Technical Service Bulletin

**AIR CONDITIONER DOES NOT BLOW COLD AIR DUE TO CRACKED
COOLER PIPE (HI) A (REFRIGERANT LEAK)**

Bulletin No.: 07-004/18

(1)	Cooler pipe (HI) A
(2)	A/C compressor
(3)	Condenser

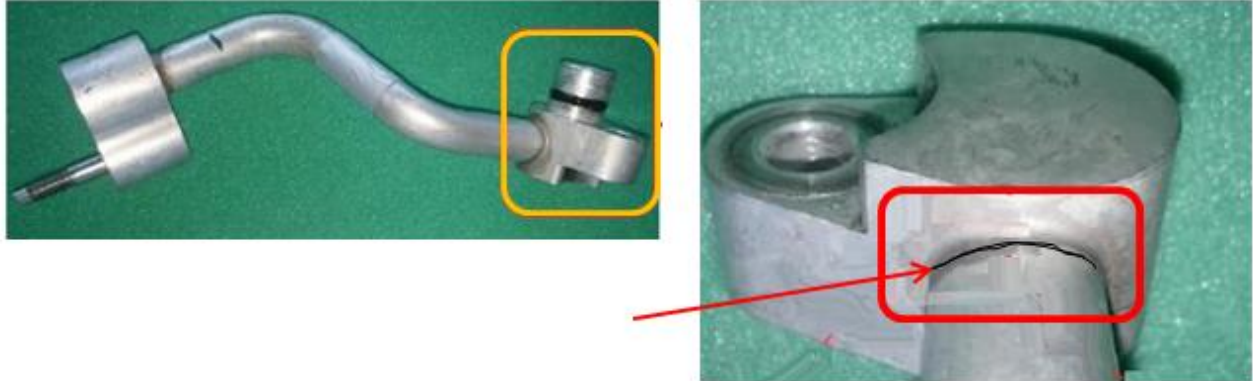
Some vehicles may experience that the A/C does not blow cold air (blows warm air) due to a refrigerant leak. This is caused by a crack in the cooler pipe (HI) A (1) due to engine vibration. To correct this issue, the material and thickness of the cooler pipe (HI) A has been changed to increase durability.

Location of cracking

1. Verify customer concern.
2. Inspect the cooler pipe (HI) A.
 - If the cooler pipe (HI) A is cracked, replace the cooler pipe (HI) A with a modified one according to the instructions on MGSS (REFRIGERANT LINE REMOVAL/INSTALLATION).
 - If the cooler pipe (HI) A is not cracked, this TSB is not applicable. Refer to troubleshooting procedure on MGSS (NO COOL AIR [CLIMATE CONTROL SYSTEM]).
3. Verify repair.
